INSPECTION REPORT
Sedimentation Structure
KM-C
Kayenta Mine
Navajo County, Arizona

for
PEABODY COAL COMPANY

Dames & Moore
10139-011-22

SITE PLAN KM-C

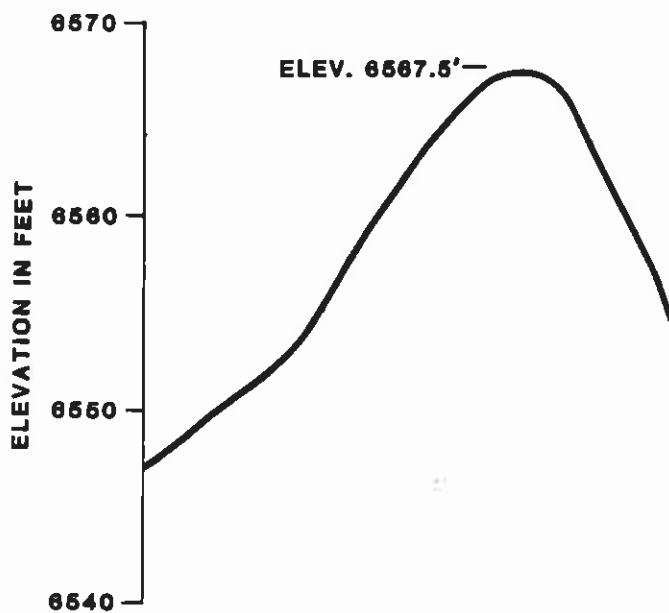
SPILLWAY SHOULD BE IN R.A. & outlet channel
 down the face of the dam

Structure KM-C has sufficient storage capacity but it does not have a spillway or outflow channel. A trapezoidal spillway channel should be constructed at elevation 6564.0 feet. The dam crest should be raised to elevation 6566.6 feet. A trapezoidal outflow channel with the same bottom width as the spillway should be constructed along the alignment shown in Plate 1. The spillway and outflow channel profile is shown in Plate 4 and the required dimensions are shown in Plate 5. Both the spillway and outflow channel should be protected against erosion using geotextile and riprap as shown in Plate 5.
